# **EB-2023-0201 – Eganville Community Expansion Project Leave to Construct Pollution Probe Interrogatories to Applicant**

# Enbridge Gas Inc. Eganville Community Expansion Project Leave to Construct

# **POLLUTION PROBE INTERROGATORIES**

Figure 1: Energy Savings (percentage) for a ccASHP compared to natural gas, oil and baseboard electric.

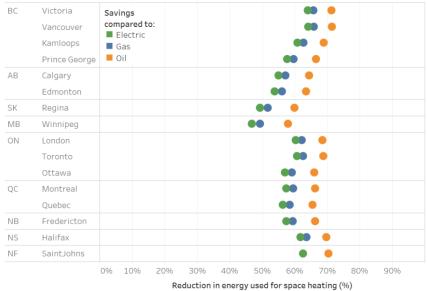
The CanmetENERGY cold-climate air source heat pump (ccASHP) Report shows a ccASHP is 50% to 70% more efficient than natural gas, oil or resistance (i.e. baseboard) electric.

- a) Please indicate whether this information for ccASHPs was shared with potential customers as part of the information related to heat pumps. If it was, please provide a copy of the information/materials provided to consumers.
- b) This information was provide in EB-2022-0200 based on a 2022 Study. If Enbridge has a more recent/relevant study/information that provides a different savings rate for ccASHPs vs. natural gas, oil or electric resistance heating, please provide a copy.
